**DETAILED RESPONSE TO REGULATORY COMMENTS ON DRAFT EA REPORT  
(VERSION 2)**

**Subject: Combined Responses to Regulatory Comments on Groundwater-related Topics, Rainy River Project Draft Environmental Assessment Report**

Combined Responses to Regulatory Comments on Groundwater-related Topics

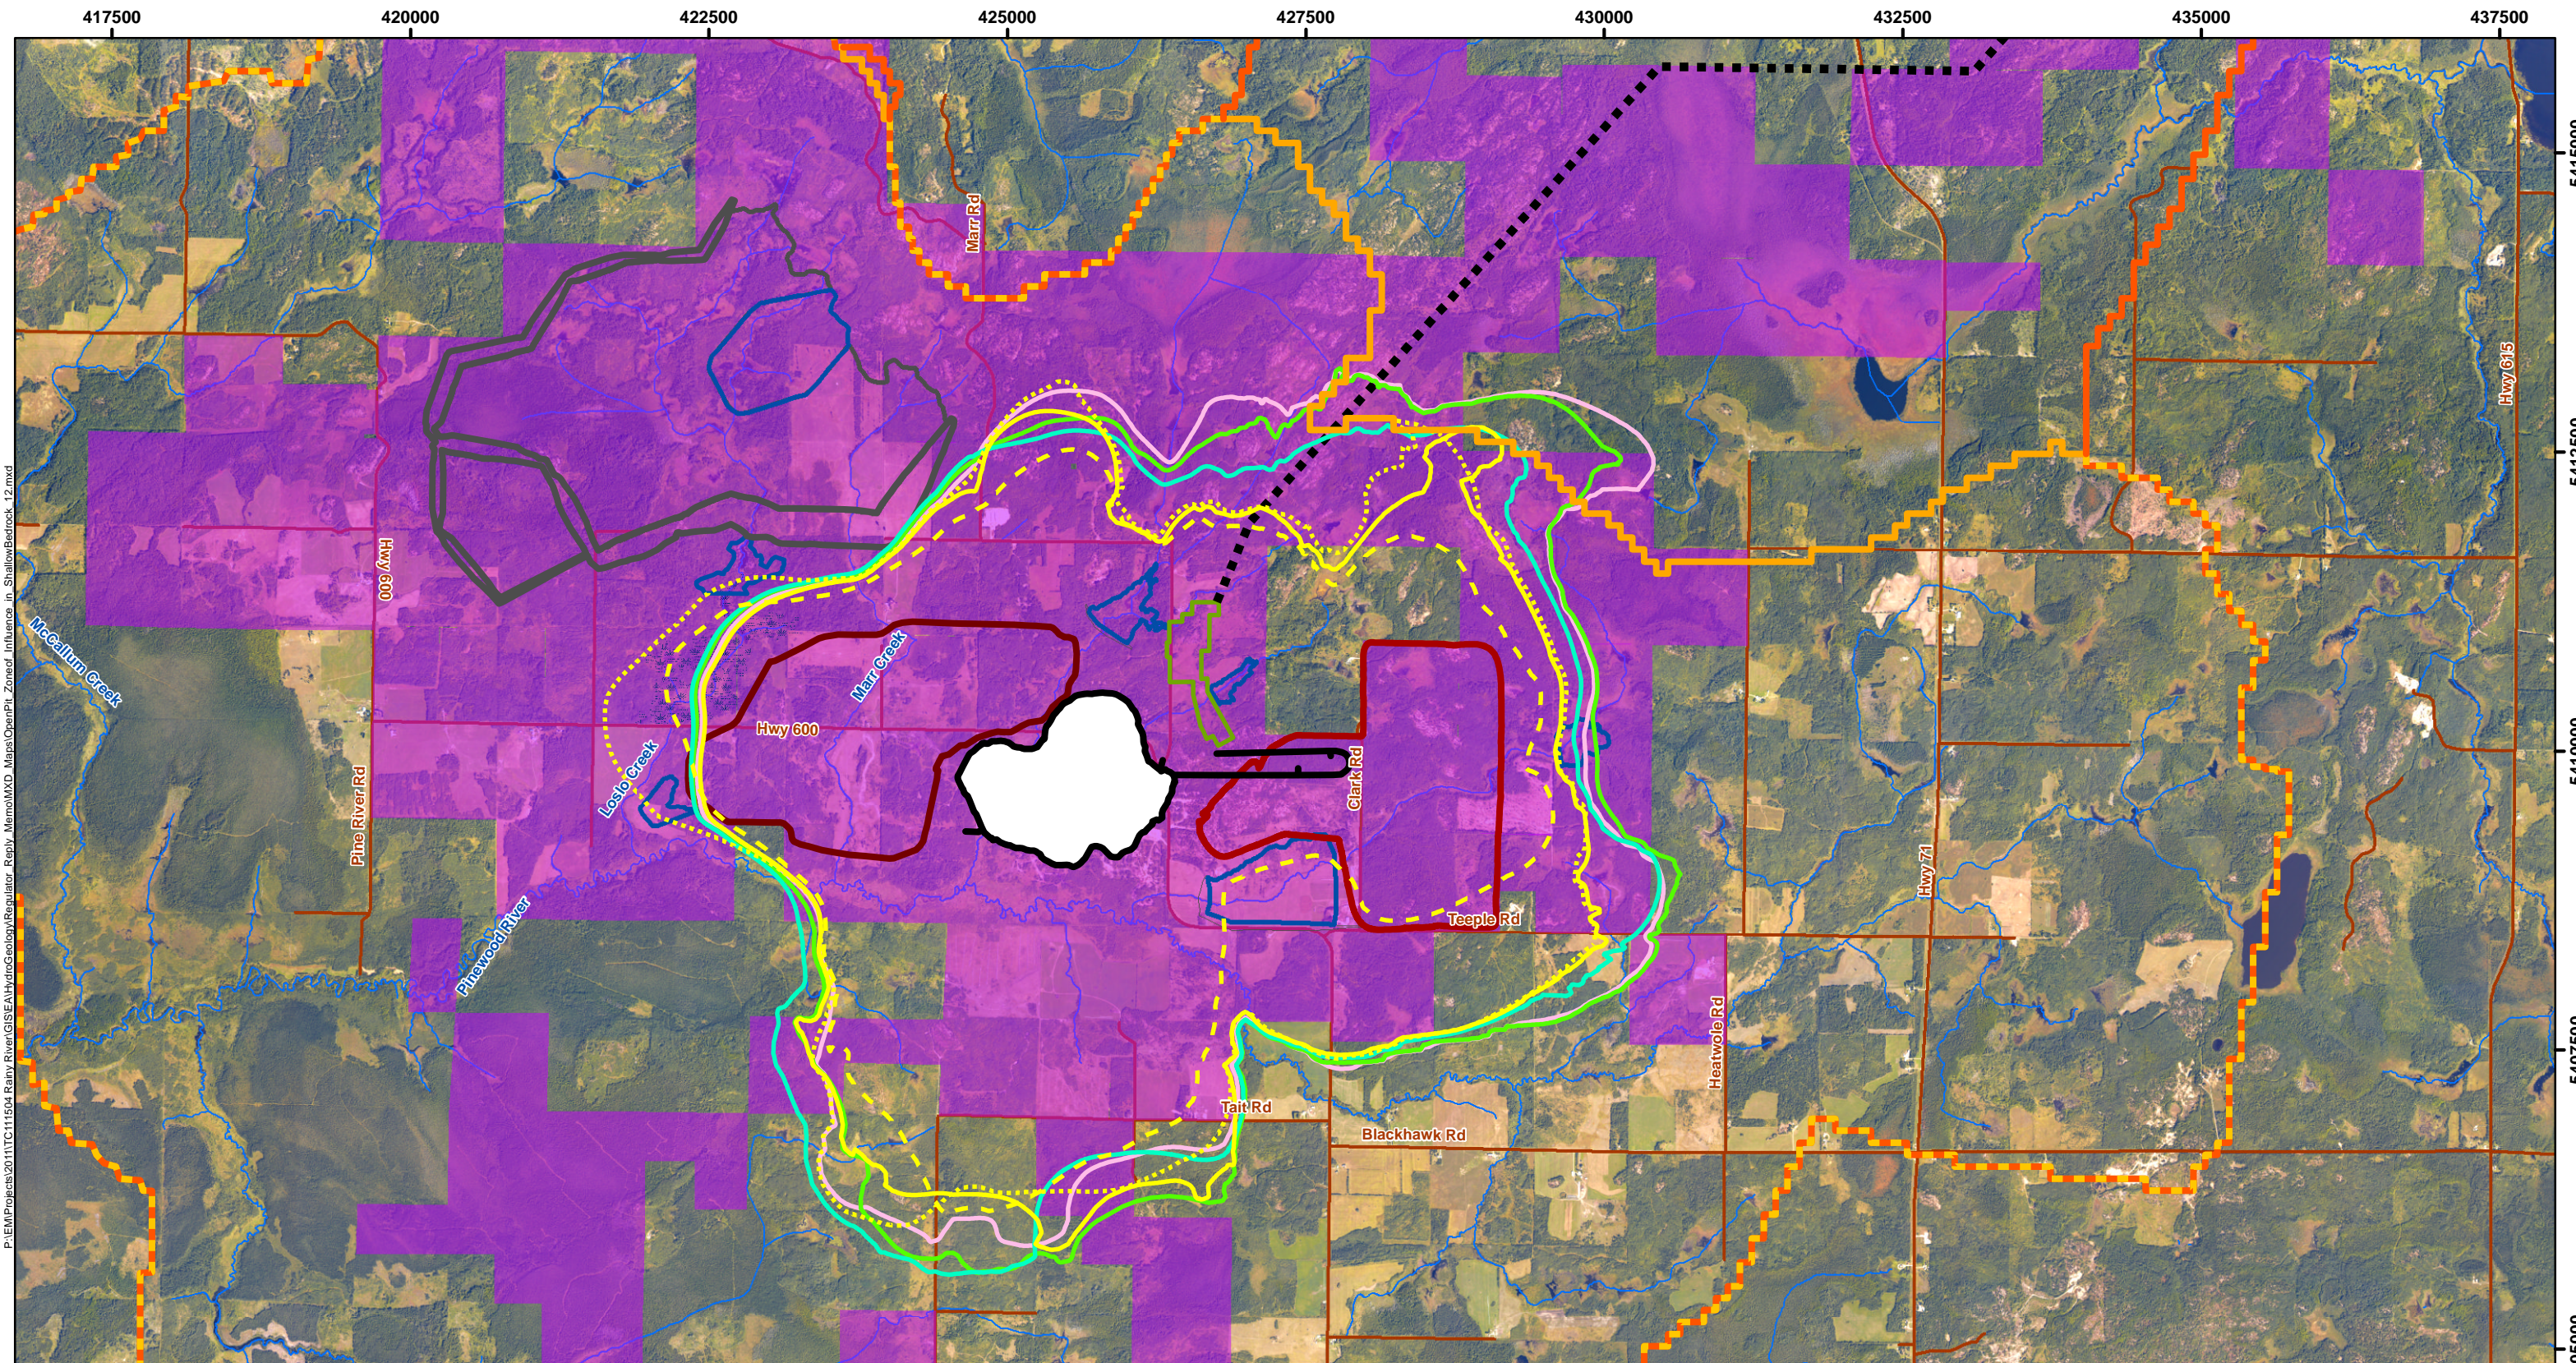
**Information Request 3:** NRCan requests that the proponent discuss the necessity of modifying the current numerical model and its planned updates (every three years following the exploitation of the open pit) to account for new boundaries.

*Response to Information Request 3: In order to fully address the NRCan comments related to the northern section of the model boundary, AMEC modified the original model by extending it to the north and east by up to 5,700 m in the area where the interaction between the computed ZOIs and the boundary was observed (Figure 1). Note that a*

*significant portion of the model extension to the north is occupied by a large wetland complex. This wetland was simulated by using the MODFLOW river nodes with a specified elevation of 378 m. Conductance of these river nodes was computed based on the assumption that the wetland is underlain by clay, having hydraulic conductivity of 1E-8 metres per second (m/s). Figure 2 shows model computed ZOIs for the Base Case, 3a and 4a scenarios, previously reported by AMEC (May 2013). This figure shows that extending the model domain results in: (i) the reduction of all ZOIs extents to the west by about 600 to 700 m; (ii) minor change of the ZOI, corresponding to the Base Case scenario in other directions; and (iii) the reduction in the estimated extent of the ZOIs, corresponding to the simulated variants 3a and 4a, by up to about 2 kilometres (km) in the northeastern direction.*

<p><b>RAINY RIVER PROJECT</b></p>	
<p><b>Predicted ZOIs for the Original and Additional Model Runs</b></p>	
<p>PROJECT N<sup>o</sup>: TC111504</p>	<p>FIGURE: 2</p>
<p>SCALE: 1:52,000</p>	<p>DATE: September 2013</p>

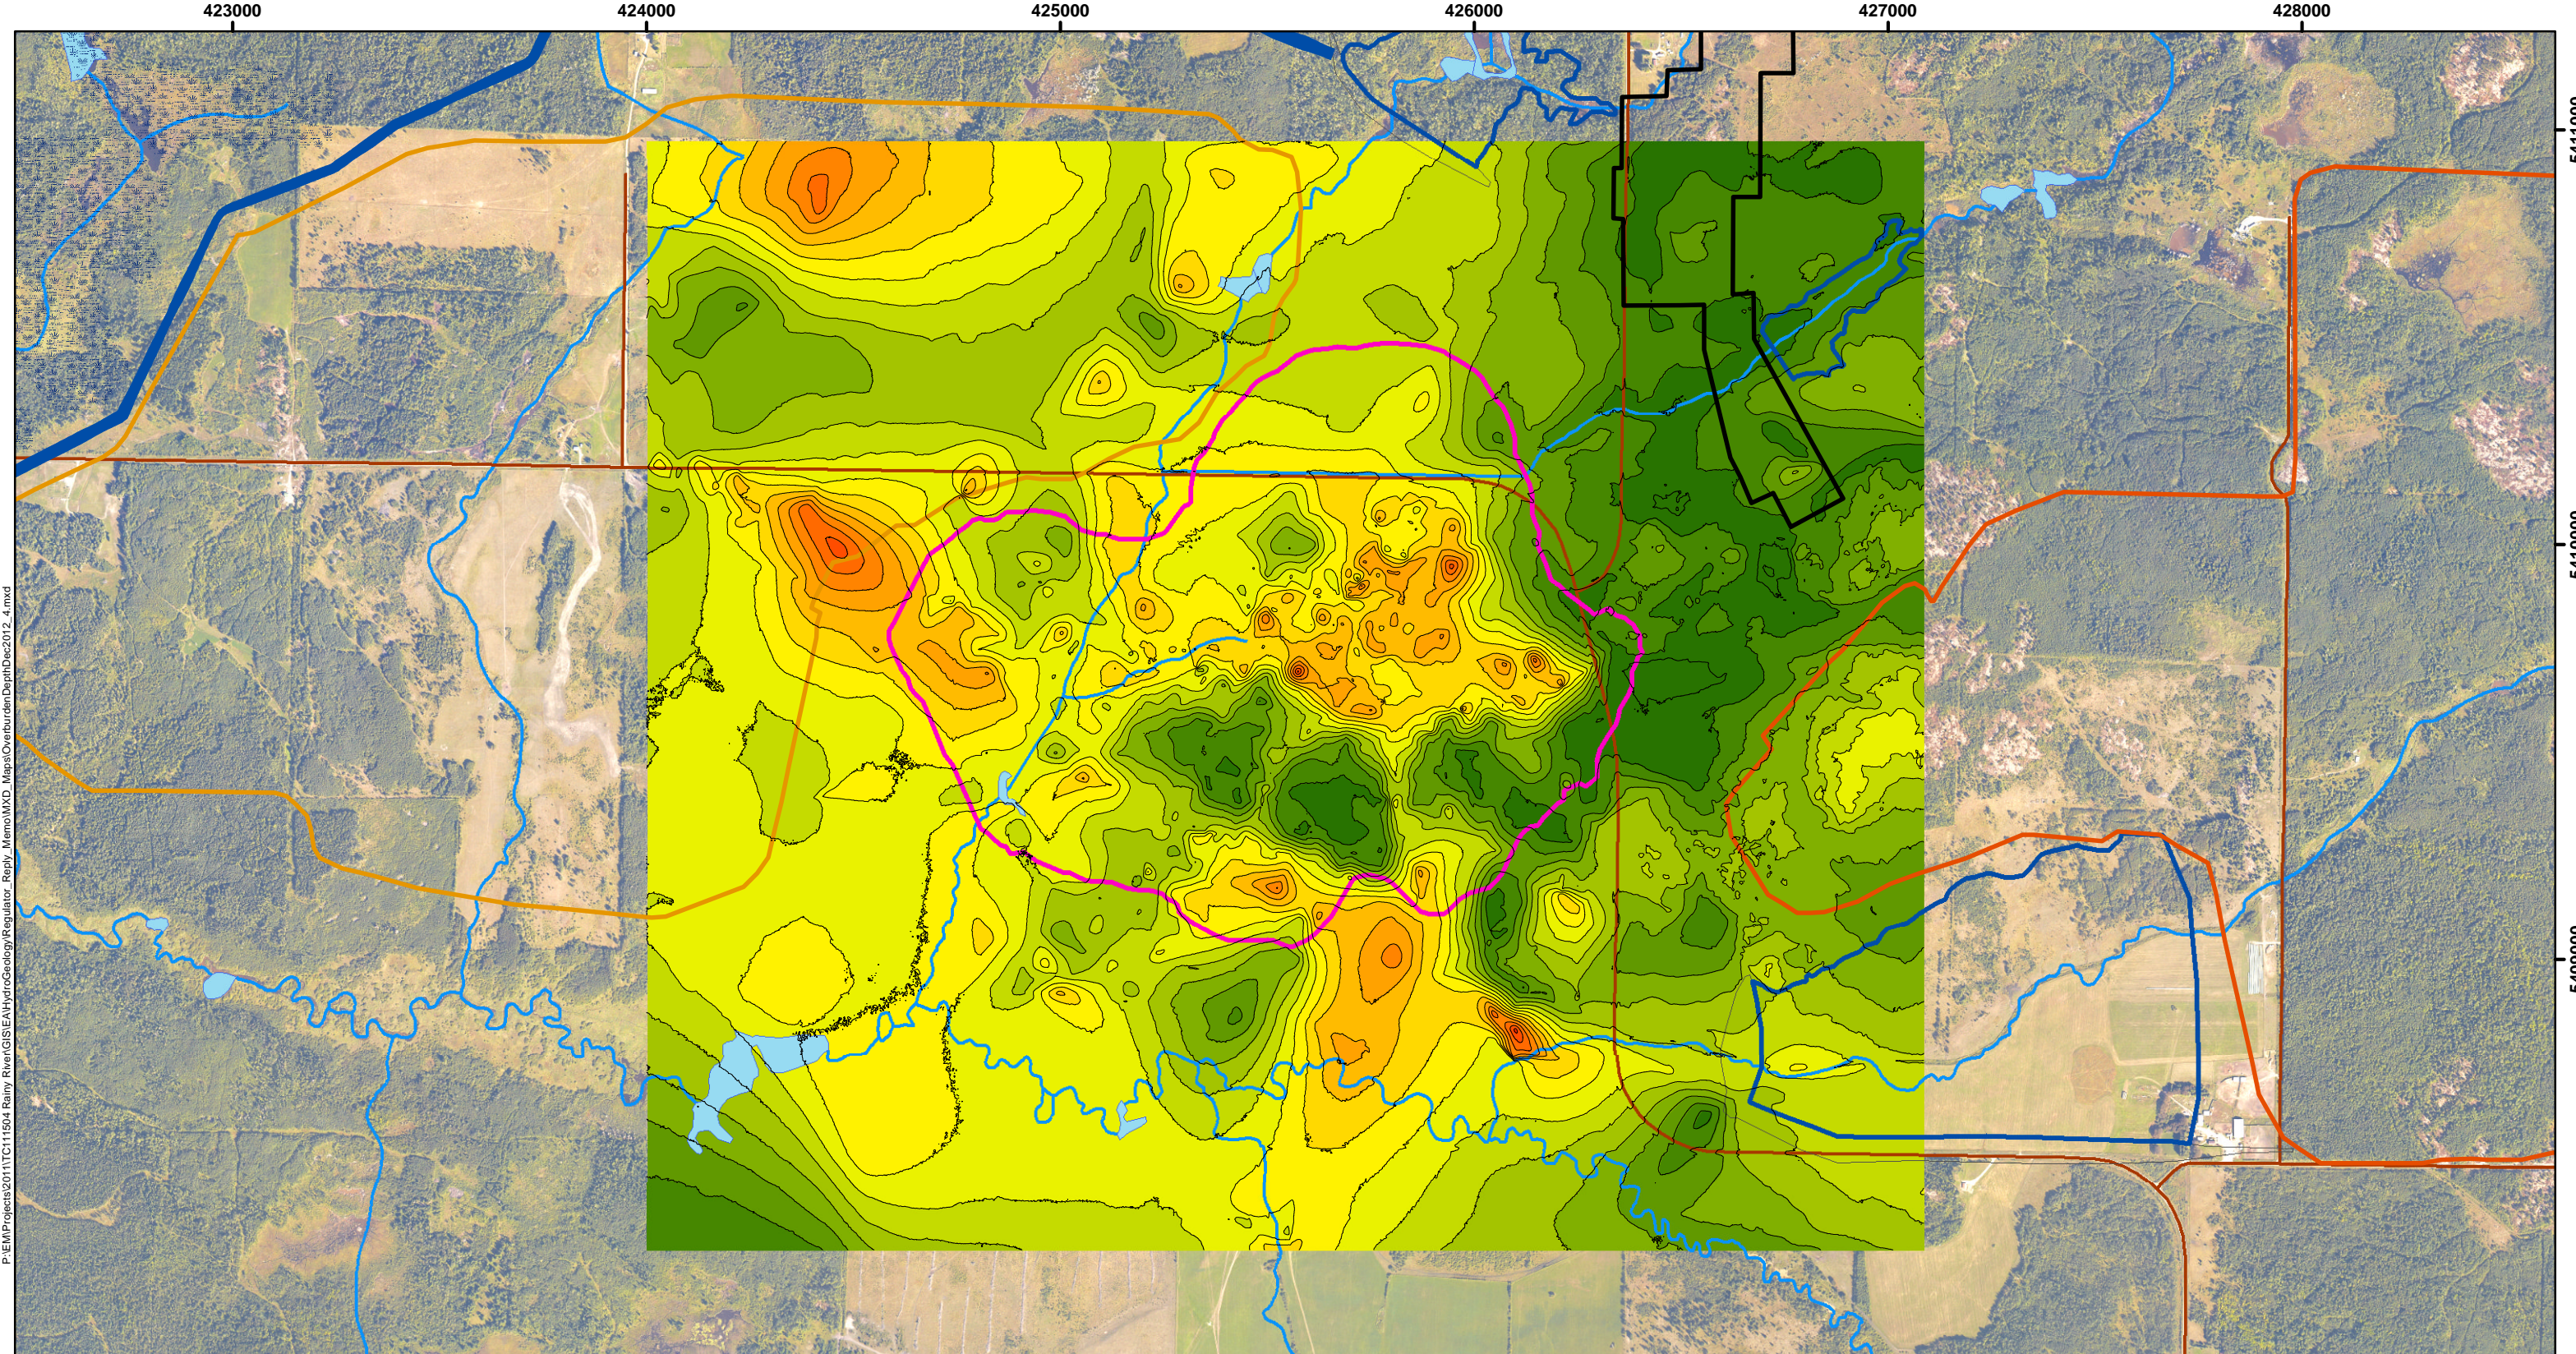
The hydrogeological model domain needs to be extended to reduce potential boundary effects. Significant changes in head are observed at the bottom boundary of the model domain (Appendix S, Figure 3-2) and it is believed that these changes could introduce inconsistencies in the simulated results. An extension of the model domain, or justification as to why it is not necessary, is needed.

It is the reviewer's opinion that the hydrogeological model domain should be of sufficient size as to observe no changes in head at the bottom boundary. Significant changes at this boundary could unrealistically alter the simulated results, introducing errors. The potential effects of these significant changes in head should be discussed and, if increasing the size of the model domain is not required, further justification must be provided.

*Response to Comment 4 as pertaining to anisotropy:* *In AMEC's opinion, there is no justification for examining potential anisotropy of the Pleistocene Aquitard, comprised of Brenna, Whitemouth Lake Till and Wylie units; since flow through these units is primarily vertical and, therefore, only vertical K-value is relevant in this case. Similarly, only the horizontal hydraulic conductivity of the lower granular deposits (PLGD) is relevant since: (i) flow in this unit is primarily horizontal; and (ii) this unit is overlain and underlain by much less permeable hydrostratigraphic units (Wylie clay and shallow bedrock). Second, potential anisotropy of bedrock can be attributed to fracture orientation. Anisotropy of the shallow bedrock zone was not considered since its fractures are related to weathering and as such are not expected to have any preferential orientation. Below the weathered zone orientation of fractures in granitic rock is expected to be either vertical or subvertical. Based on the above, only the impact of bedrock anisotropy below the shallow weathered zone was examined as per the MOE comment. Analysis was carried out by increasing vertical hydraulic conductivity of the intermediate and deep bedrock zones by a factor of 10, resulting in the anisotropy coefficient, or the  $K_h/K_v$  ratio, of 1:10. As a result, model predicted seepage rate increased by 290  $m^3/d$  or about 8.5%, compared with the seepage rate of 3,400  $m^3/d$  for the Base Case scenario. Figure 2 shows model predicted ZOI corresponding to the simulated  $K_h/K_v=10$  case. Note both*

*model predicted change in seepage rate and the extent of ZOI are within the range of the previously reported uncertainty in the model results (AMEC May 2013).*

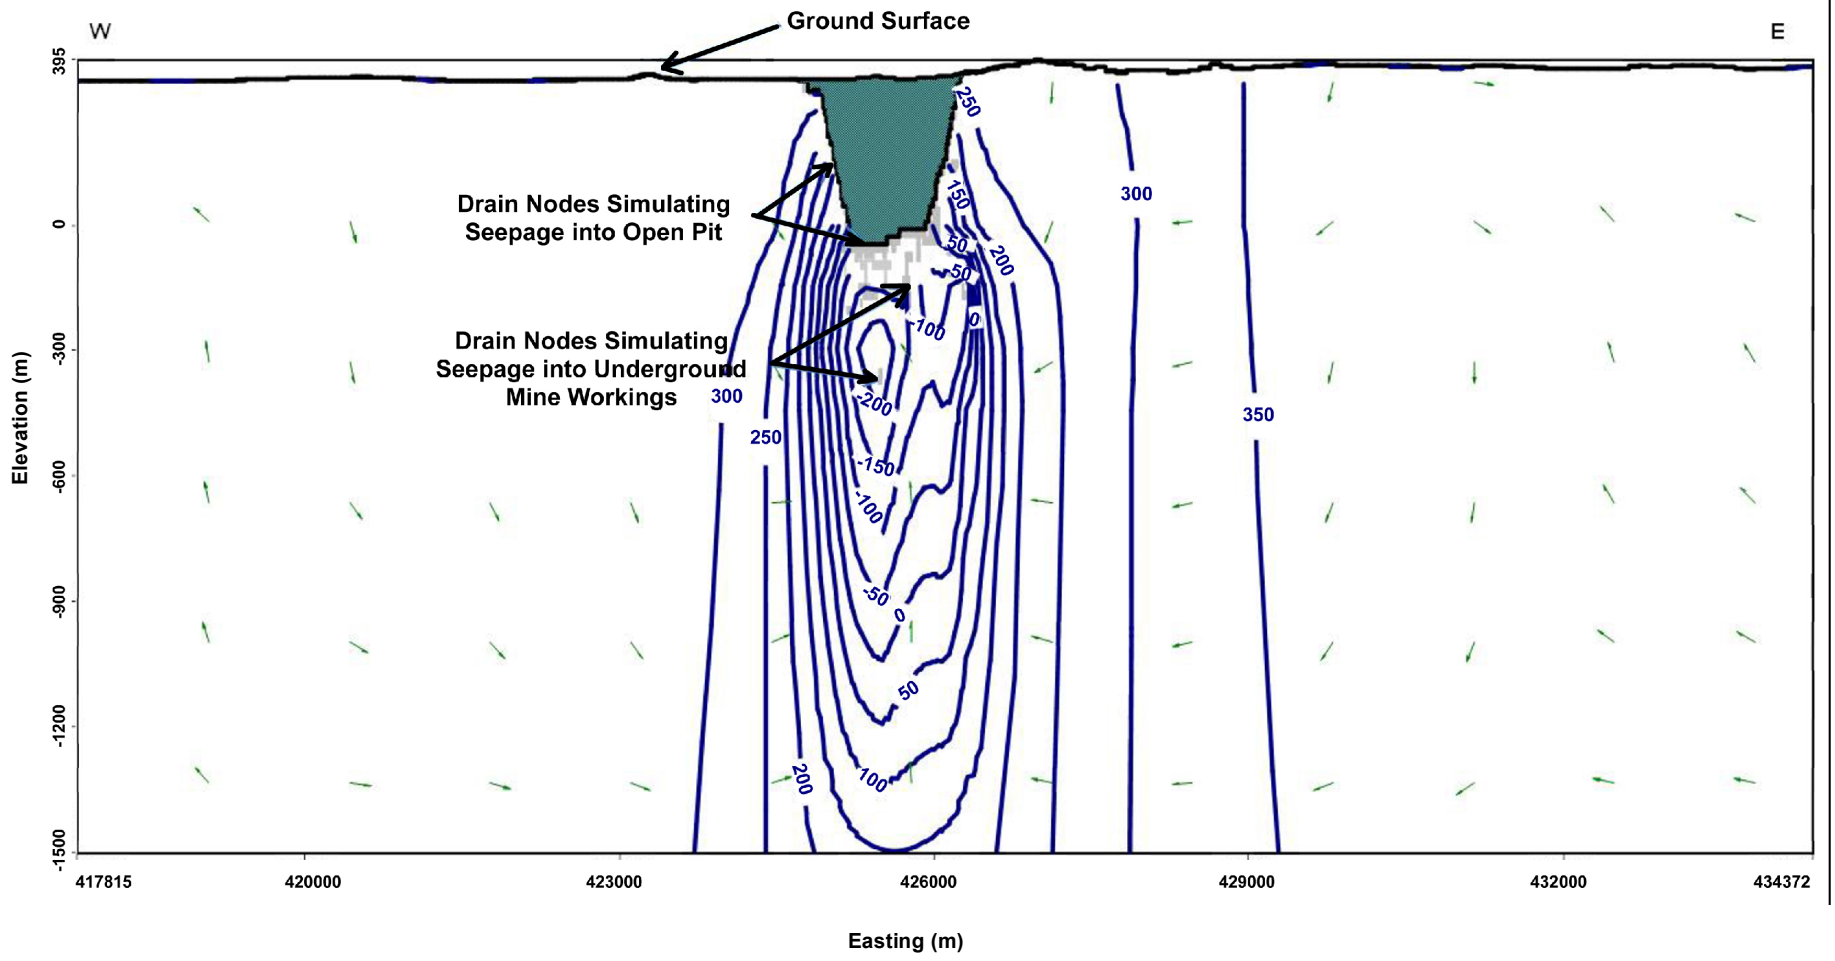
The hydrogeological model does not address the potential to induce consolidation due to dewatering; or settlement in the thick clay layers onsite due to the loading associated with surface features such as the TMA and the east mine rock stockpile. While this subject is mentioned in Section 4, a full description of the expected behaviour of the thick clay layers when subject to loading and the potential consequences does not appear to be present.

The potential for such consolidation should be considered, with likely environmental or structural impacts and mitigation and contingency options discussed in the EA.

*Settlement was not calculated for areas where there is only thin overburden, where the drawdown is minor, or there are large infrastructure planned (i.e., beneath the overburden stockpile); as either the settlement will be small, or the planned infrastructure already dominates the drainage changes and will prevent the creation of ponds. This leaves two general areas of thick overburden near the pit that are not covered by infrastructure (Figure 3): one on the south side of the Pinewood River, south of the open pit where the overburden is approximately 50 m thick (Area a), and one to the north of the open pit where the overburden is approximately 40 m thick (Area b).*

*For Area a, near the Pinewood River, the estimated drawdown was predicted for the base of the overburden from the groundwater model at the end of mining (AMEC May 2013), but there was assumed to be no drawdown at surface near the Pinewood River and an average drawdown of 5 m was applied to this area. Consolidation settlement due to groundwater depletion in this area is estimated to be between approximately 0.2 to 0.3 m. The existing topography in this area varies by approximately 4 m, and settlement at these amounts is unlikely to lead to development significant areas of ponding or the redirection of drainage.*

*For area b, north of the open pit, the drawdown was assumed to be 15 m. Consolidation settlement due to groundwater depletion in this area is estimated to be between approximately 0.5 to 0.6 m. The existing topography in this area varies by approximately 10 m, and settlement at the estimated amounts is unlikely to lead to development significant areas of ponding or the re-direction of drainage. Furthermore, re-grading of the area is proposed to create the west creek pond and for the re-alignment of west creek.*
